LEGAL NOTICE EXETER PLANNING BOARD AGENDA

Date: April 7, 2022
To: Planning Board
From: Dave Sharples, Town Planner
Re: Phillips Exeter Academy PB Case #22-2

Re: Site Plan Review TRC Comments - Phillips Exeter Academy
PB Case #22-2 Faculty Neighborhood Project, High Street & Gilman Lane
Tax Map Parcel #71-117, #71-118 and #71-119

**RE: Application for Site Plan Review, Lot Line Adjustment,
& Conditional Use Permit – Shoreland District
High Street Faculty Neighborhood Development
Tax Map 71, Lots 117-119
Case #2022-02**

Figure 3-15: BMP Performance Curve: Enhanced Bio-filtration with Internal Storage Reservoir (ISR)
BMP Performance Table

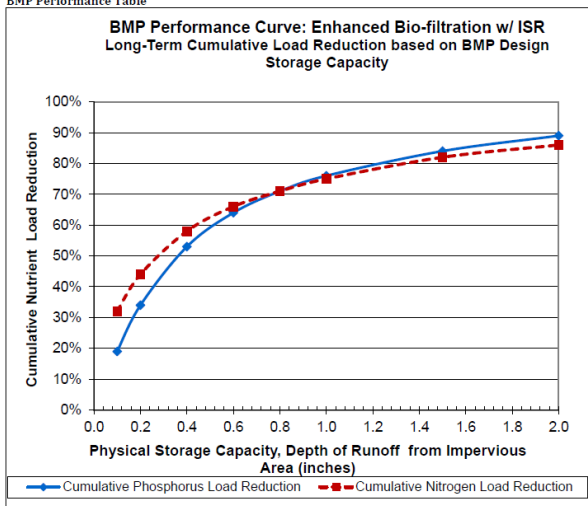
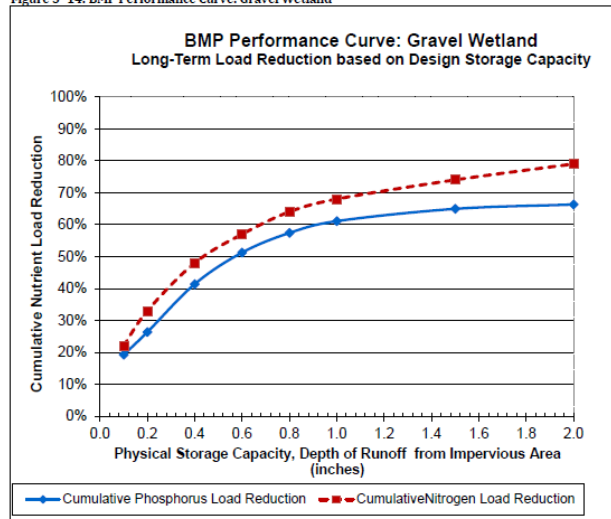
1. Explore potential to use a gravel wetland as it provides a more effective SS, TIN, TN, TP removal efficiencies to replace raingarden 2.
2. Label man-made wetland as such for wetland near the riverside outlet structure by Raingarden #2.

The previously proposed Bioretention raingarden and the ISR system both have an 18-inche rock base and 18-inches of filter media. The primary difference between the two systems is that there is an impermeable liner in the ISR system and the outlet pipe is raised. This forces a longer travel path for the stormwater and a saturation zone in the storage (reservoir) area which increases nitrogen and phosphorus removal.

Based on the performance curves from the UNH Stormwater Center for the ISR pollutant removals and the modeling results for the system, Altus recommends the ISR system for use in this condition to meet the conditions for increased pollutant removals and stormwater management.
